<b>Title - Sujet</b> Radar Hill Viewpoint Shelter	
<b>Solicitation No. - N° de l'invitation</b> EZ899-160310/A	<b>Amendment No. - N° modif.</b> 003
<b>Client Reference No. - N° de référence du client</b>	<b>Date</b> 2015-07-08
<b>GETS Reference No. - N° de référence de SEAG</b> PW-\$PWY-022-7533	
<b>File No. - N° de dossier</b> PWY-5-38035 (022)	<b>CCC No./N° CCC - FMS No./N° VME</b>
<b>Solicitation Closes - L'invitation prend fin</b> <b>at - à 02:00 PM</b> <b>on - le 2015-07-16</b>	<b>Time Zone</b> <b>Fuseau horaire</b> Pacific Daylight Saving Time PDT
<b>F.O.B. - F.A.B.</b> <b>Plant-Usine:</b> <input type="checkbox"/> <b>Destination:</b> <input checked="" type="checkbox"/> <b>Other-Autre:</b> <input type="checkbox"/>	
<b>Address Enquiries to: - Adresser toutes questions à:</b> Arthur (PWY), Carolyn	<b>Buyer Id - Id de l'acheteur</b> pwy022
<b>Telephone No. - N° de téléphone</b> (604) 775-6667 ( )	<b>FAX No. - N° de FAX</b> (604) 775-6633

Radar Hill, BC  
Radar Hill Viewing Shelter  
2015-07-07

**ADDENDUM #2**

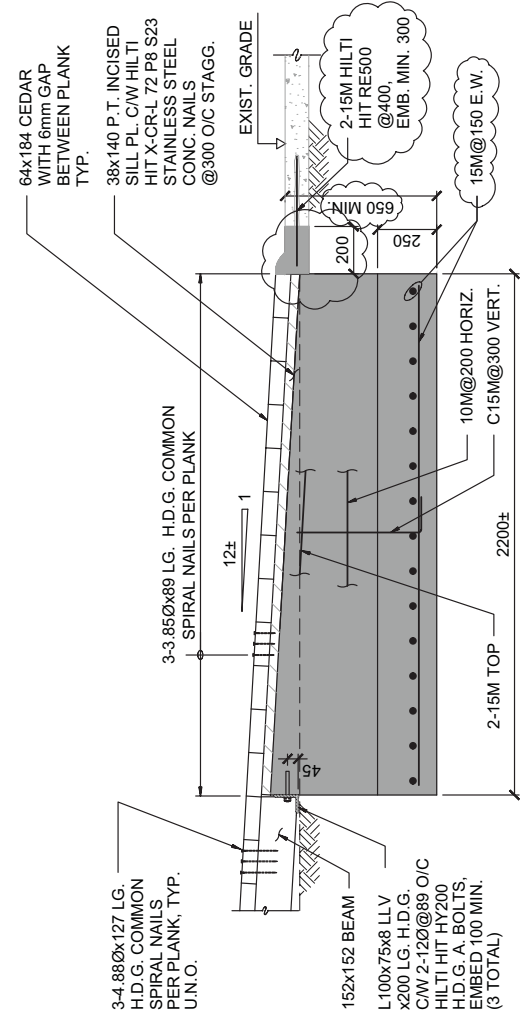
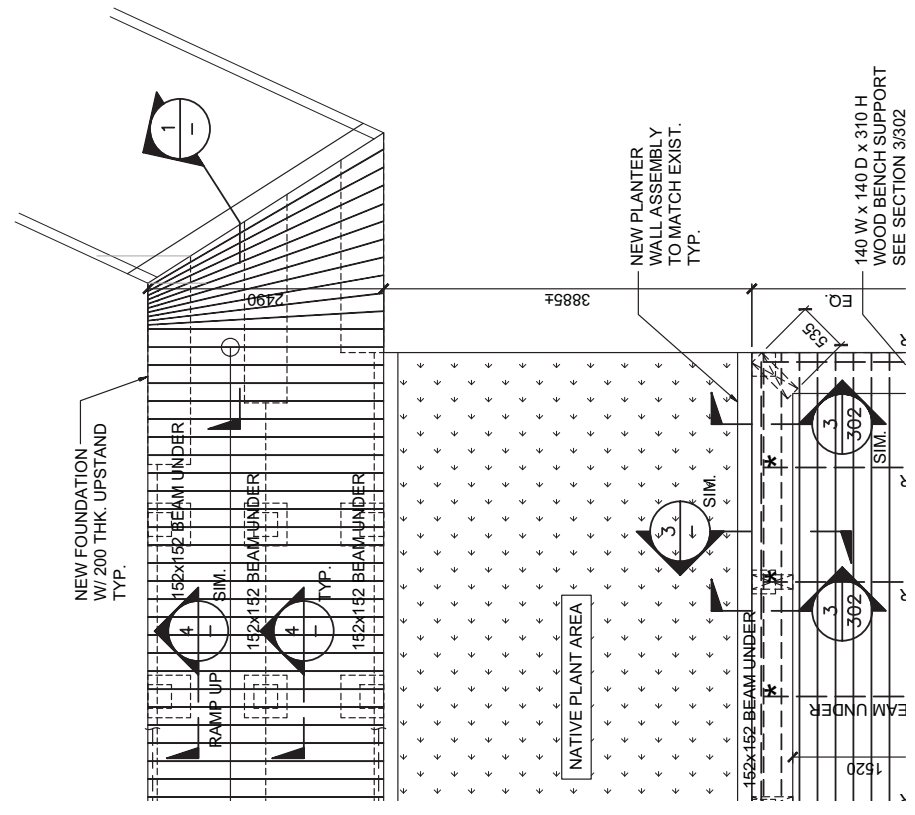
- 1.1 **Field Review: Revise** Addendum No. 1 item 1.2 as, ".2 Field Review pertaining to approval of bearing surface shall be carried out by Departmental Representative. Testing of engineered fill that supports foundation elements shall be carried out by Independent Testing Agency approved by Departmental Representative."
- 1.2 **Add** notes to New Top South Platform, "Replace existing wood platform with new cedar wood deck, wood bench/planter box wall/curbs & 152x152 wood beam; refer to section4/- for similar new beam joint details.
- 1.3 **Revise** plan & section 1/201 as per sketches AD01-Rev.A & AD06.
